ENERGY NORTHWEST

February 8, 2010
GO2-10-024

**Subject: COLUMBIA GENERATING STATION, DOCKET NO. 50-397
LICENSE AMENDMENT REQUEST TO CHANGE TECHNICAL
SPECIFICATIONS RELATING TO CONTROL ROD OPERABILITY AND
CONTROL ROD SCRAM ACCUMULATORS**

**LICENSE AMENDMENT REQUEST TO CHANGE TECHNICAL SPECIFICATIONS
RELATING TO CONTROL ROD OPERABILITY AND CONTROL ROD SCRAM
ACCUMULATORS**

BASES (continued)

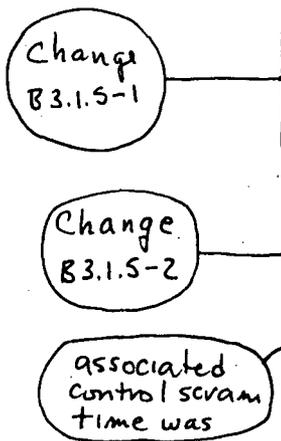
LCO The OPERABILITY of the control rod scram accumulators is required to ensure that adequate scram insertion capability exists when needed over the entire range of reactor pressures. The OPERABILITY of the scram accumulators is based on maintaining adequate accumulator pressure.

With one control rod scram accumulator inoperable and the reactor steam dome pressure ≥ 900 psig, the control rod may be declared "slow" (~~after declaring the average scram times in all two-by-two arrays associated with the control rod with the inoperable accumulator not within the limits of Table 3.1.4-1~~), since the control rod will still scram at the reactor operating pressure but may not satisfy the required scram times in Table 3.1.4-1. Required Action A.1 is modified by a Note, ^{indicating} ~~which clarifies~~ that declaring the control rod "slow" is ^{only applicable} ~~only applicable~~ if the ~~average scram times of the two by two arrays associated with the control rod with the inoperable accumulator are~~ ^{test} ~~within the limits of~~ Table 3.1.4-1 during the last scram time ^{test} ~~surveillance~~. Otherwise, the control rod may already be considered "slow"
